## Responses to Comments on DG-1247

Draft regulatory guide DG-1247, and two technical references to it, NUREG/CR-7004 and NUREG/CR-7005, were issued for public comment. Two public comments were received. A third comment generated internal to the NRC was also considered. This document contains the staff's understanding of the three comments and the staff's responses to them.

**Comments on Draft Regulatory Guide DG-1247  
Design-Basis Hurricane and Hurricane Missiles for Nuclear Power Plants**

**Figure 1. Comparison of modeled and observed peak gust wind speeds for Hurricane Charley showing the inland extent of strong winds. Note the high winds in Orlando (KMCO) which is 200 km inland from the landfall location. Dashed lines shown in the scatter plot indicate  $\pm 10\%$ .**

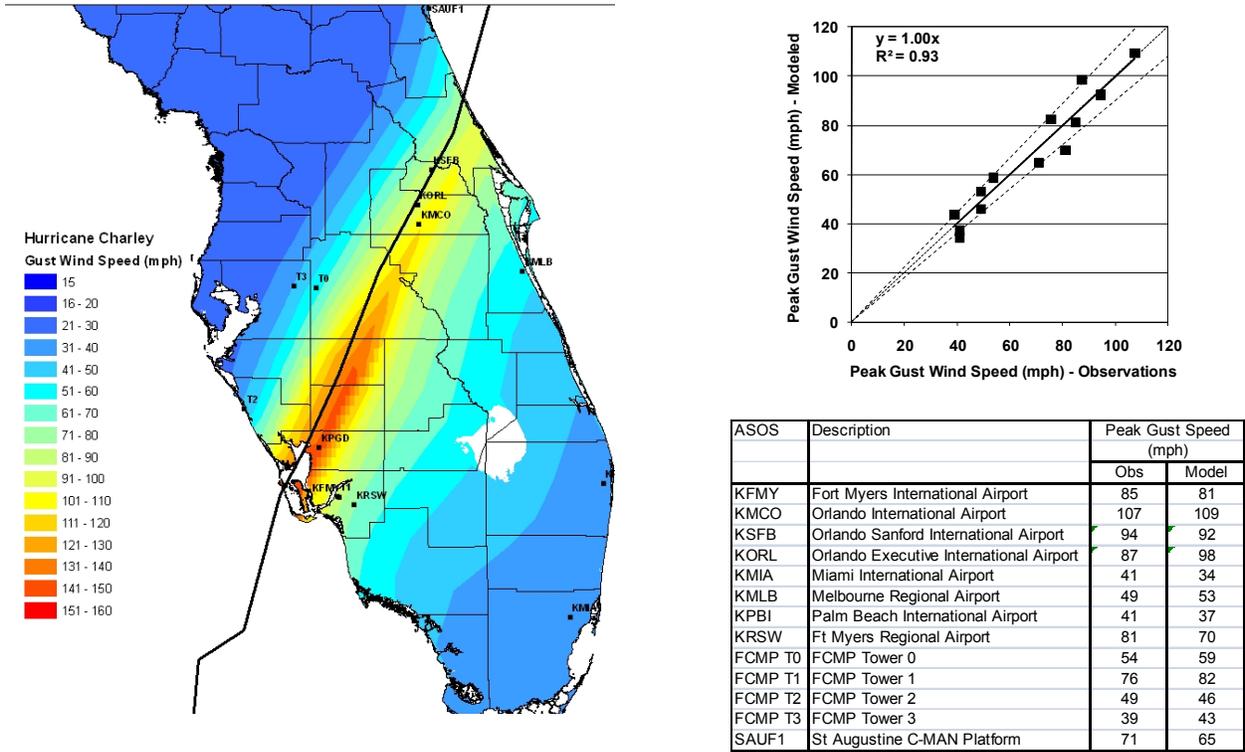
**Comment within the introductory paragraph.** “...the methodology has resulted in a significant departure from historical wind speed data and has significantly extended these wind speeds inland.”

**Response:** *The wind field model has been validated using historical wind speed data as described in numerous papers and reports (e.g. Vickery et al., 2000, Vickery et al., 2009a). Those comparisons indicate that the model performs well both at the coast and inland. Many of these comparisons were presented in the Technical Basis document NUREG/CR-7005, as well as in Vickery et al. (2009a). The inland wind speeds are based upon the well validated wind field model that properly treats the sea-land transition and the growth of the hurricane boundary layer as the storm progresses inland. This wind model is coupled with a filling model (increase in central pressure as the storm moves inland) which is described in detail in Vickery (2005). The filling model weakens hurricanes fastest in the case of small, intense, fast moving hurricanes, such as Hurricane Charley. Figures 1 and 2 present model gust wind swaths for the 2004 Hurricanes Charley and Jeanne in Florida. Notice the inland extension of the strong winds associated with both hurricanes. The marine winds (which are 10% to 15% higher than the open terrain winds) are not shown in these Figures. Also note the good agreement between modeled and observed winds at both near coast and inland locations.*

We also note that strong winds have extended well inland in historical events, including, for example, the 1938 Long Island Hurricane, Hurricane Hazel (1954), Hurricane Hugo (1989) and Hurricane Charley (2004). The modeled wind swath along with measured peak gust wind speeds for Hurricane Charley were shown in Figure 1, and demonstrate the inland extent of strong winds. Figure 6 presents the wind swath for Hurricane Hugo (1989) and the associated measured wind speeds. Finally, quality wind speed measurements have not been available from land based locations prior to about 20 years ago, and even 20 years ago wind speed data from hurricanes at inland locations were few. It is also worth pointing out that at many airport locations in the US the measured winds understate the true open terrain winds due to the effects of upstream terrain. In the analyses performed by ARA, where possible, the measured winds have been adjusted for terrain effects. These local terrain effects are discussed in Masters et al. (2010).

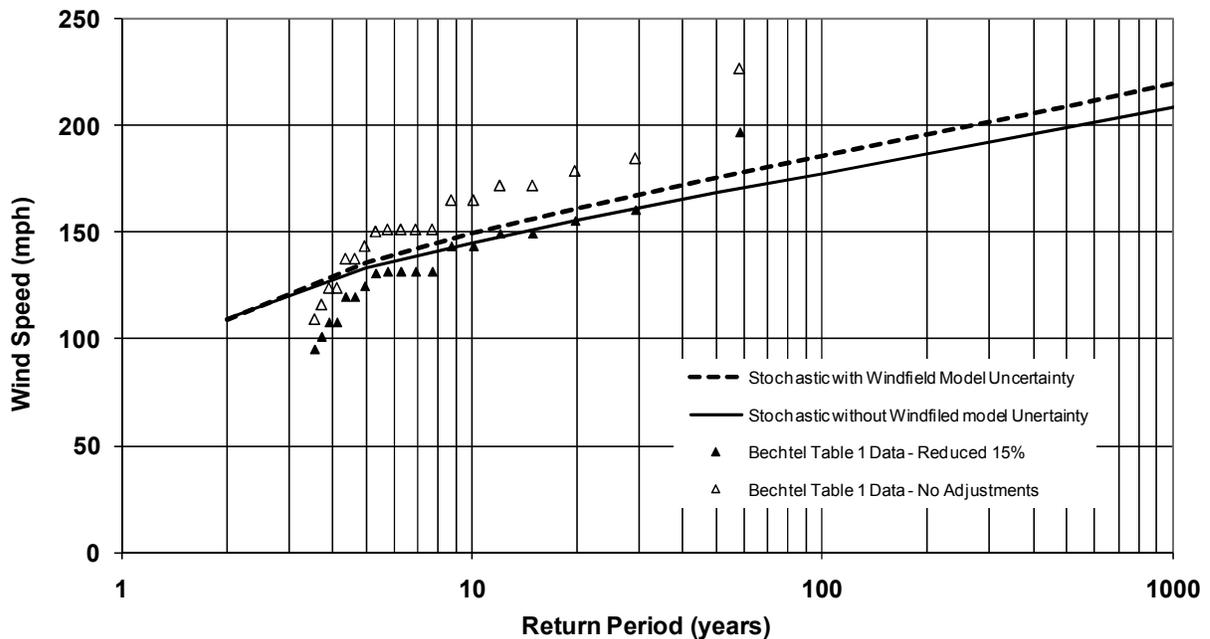
**Comment 1.** In the five coastal regions the design-basis gust winds provided in DG-1247 are often more than 30% higher than the HURDAT wind speed values obtained from historically significant hurricanes. Table 1 summarizes the significant storms that were investigated for this study. This set was selected based on damage caused at landfall and damage during the inland progress of the storm. Storm tracks are provided in attached Figures 1a – 1m, and the proposed contours from DG-1247 are superimposed on these figures. Consideration should be given to calibration of the  $10^{-7}$  per year gusts to historical values for land-falling wind speeds.

**i) Regional Analysis** A more reasonable comparison using the data given in Bechtel’s Table 1 is to show ARA’s predicted hurricane hazard curve along with an empirically based hazard curve developed using the Bechtel data (from their Table 1) that applies to a large region, the size of the coastal United States. This comparison is shown in Figure 3. The hazard curve

generated from the simulated hurricanes represents a hazard curve for any point, anywhere in the entire United States. (i.e., the curve reflects the average return period expiring, or exceeding, the indicated wind speed anywhere (on land) in the continental United States, rather than at a point). The hazard curve was derived by retaining only the maximum wind speed from each simulated hurricane, irrespective of the location of the maximum wind speed.

The empirical hazard curve obtained from the Bechtel data was developed using a similar approach, where we rank ordered the gust wind speeds given in Table 1. (If two wind speeds appear in the gust wind speed column in Table 1, we used the values labeled H). A CDF was then computed from the rank ordered data and used in a Poisson based risk model (with the annual occurrence rate defined as the total number of wind speeds (19) divided by the total number of years (57)), to develop a wind speed hazard curve. Two empirically based curves were developed, one for the case where the wind speeds given in Table 1 were used without modification, and the other developed assuming the wind speeds given in Table 1 are marine values, and so we convert them to land based values by reducing the gusts by 15%. This 15% value is suggested by Bechtel, but it overstates the true reduction in the peak gust wind speed as the wind moves from a marine terrain to an open terrain, which varies between 10% and 15%, but is closer to the 10% value.

In the case of the stochastic wind speeds, since information on the exact model grid point location of the storm-by-storm maximum obtained from the model is not known, but we do know that the distance from the coast of the grid points that likely experienced the maximum wind range from about a hundred meters to a kilometer or so. Therefore these winds will not have been fully transitioned from marine conditions to open terrain conditions, thus we expect the two sets of Bechtel winds to bracket the stochastic model wind speeds (assuming the Bechtel wind speeds are reasonable estimates of the true storm maxima).

The comparison in of the Bechtel winds and the model winds in a rationale manner as seen in Figure 1 indicates that the return periods associated with the model winds agree with, or are higher (indicating that the model yields approximately equal or lower winds for the same return period) than those derived from the wind data provided by Bechtel.

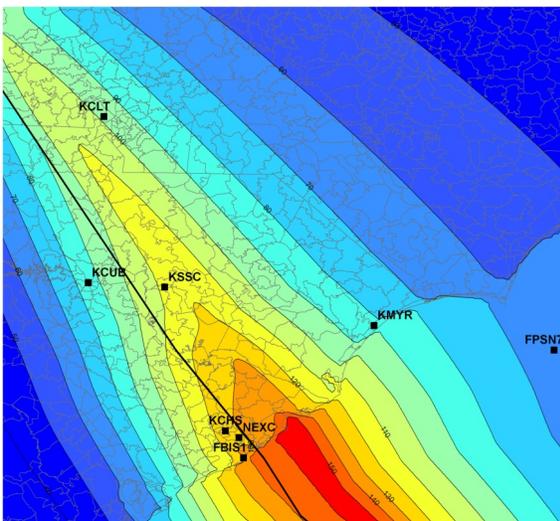
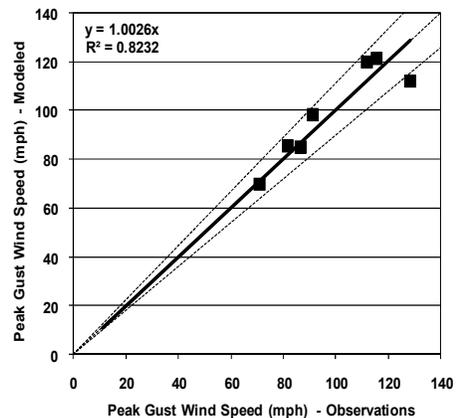
*“Simplified HURDAT data were examined for Category 4 and 5 storms for storm motion. Storms with more rapid forward movement tend to have direction changes to the east, accelerating forward motion immediately preceding rapid decreases in intensity. These are indicative of hurricane interaction with mid-latitude troughs and weakening. The rapid decrease in intensity of these observed storms suggests that while some storms can be observed to have this high forward speed, this subset would be weakening prior to landfall, and the subsequent loss of inflow after landfall would decrease the overall intensity faster than the DG-1247 model predicts. In general, it has been concluded that hurricane wind speeds in flat terrain decrease by about 15% in the first 15 km from the coast (Reference 14).”*

*Furthermore, the model does include a reduction in peak gust wind speed moving from sea to land. This reduction is in the range of 10% to 15%, varying primarily with storm size, and is evident in Figure 6 (discussed below).*
